MECKLENBURG COUNTY
DEPARTMENT OF ENVIRONMENTAL HEALTH

APPLICATION FOR SOIL INVESTIGATION

SITE EVALUATION

S.I.R. NO. 19841

**See Diagram on Back (includes: soil areas, property lines, roads, streams, gullies, wet areas, fill areas, wells, water bodies, slopes)

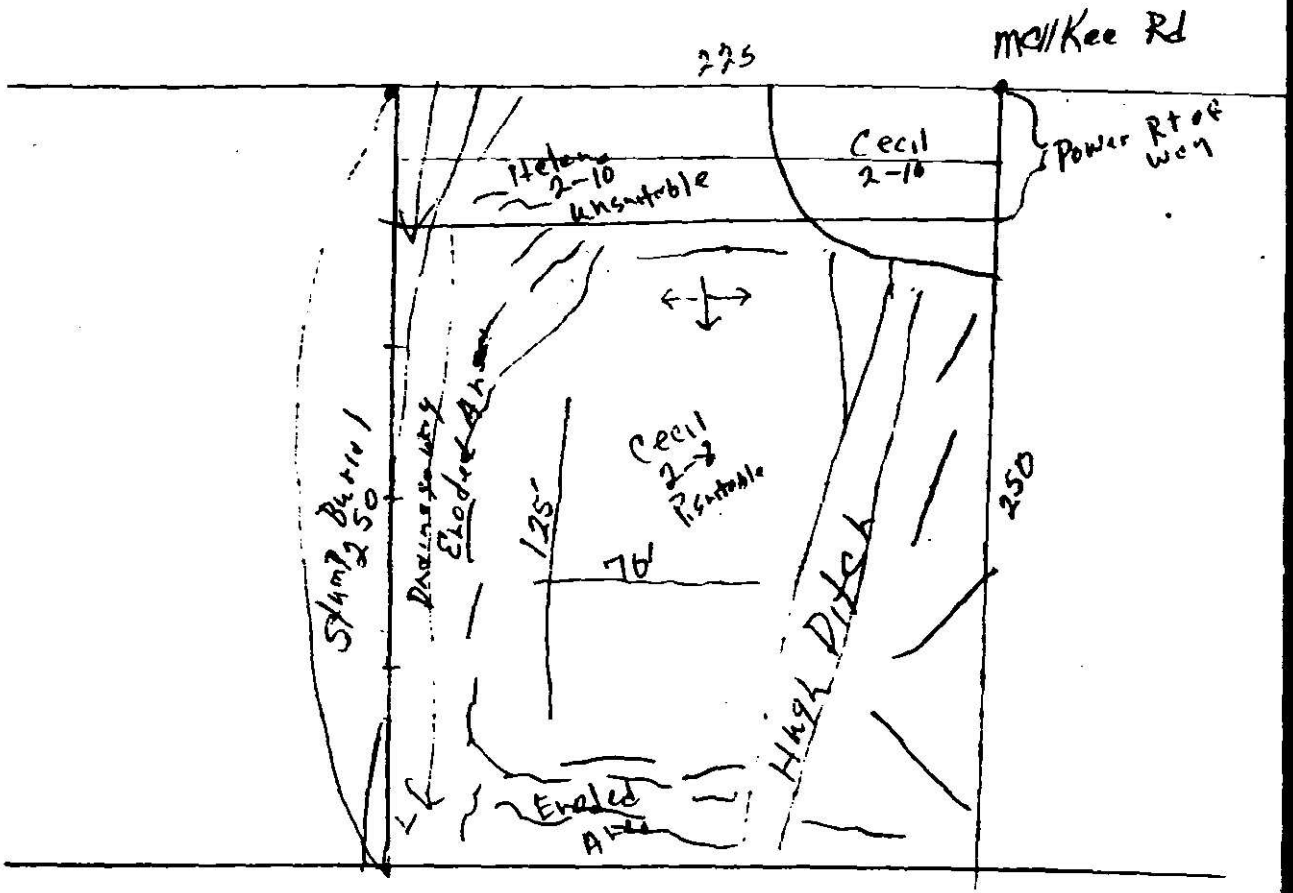
FACTORS	AREA 1	AREA 2	AREA 3	AREA 4
1. SLOPE (%)	S (PS) U: 2-12	S PS (U): Complex slopes	S (PS) U: 2-6	S PS U
2. SOIL TEXTURE (12-36 inches) Sandy, Loamy, Clayey (Note 2-1 Clay)	S (PS) U: clayey	S (PS) U: Clayey	S PS (U): Mixed Clay	S PS U
3. SOIL STRUCTURE (12-36 inches)	S (PS) U: Blocky	S (PS) U: Blocky	S PS (U): weak Blocky	S PS U
4. SOIL DEPTH (inches)	S (PS) U: 40-45	S PS (U): 0-20	S PS (U): 20-35	S PS U
5. RESTRICTIVE HORIZONS (Inches) (Impervious strata, Rock)	S (PS) U: None	S (PS) U: None	S PS (U): Clay	S PS U
6. SOIL DRAINAGE/GROUNDWATER (external and internal)	S (PS) U: Adequate	S (PS) U: Adequate	S PS (U): Slow	S PS U
7. OTHER (Specify) Restricted Area	S PS (U)	S PS U	S PS U	S PS U
8. SOIL GROUP	IIb	IIa	IIe	
9. SITE CLASSIFICATION	Unsuitable	Unsuitable	Unsuitable	
10. SOIL SERIES	Cecil	Complex slopes in Cecil	Vance

McKee Rd
225
Cecil
2-10
Power R/W
Cecil
2-10
Unsuitable
Cecil
2-10
Unsuitable
125'
70'
250
250
Ponded
Ponded
High Ditch
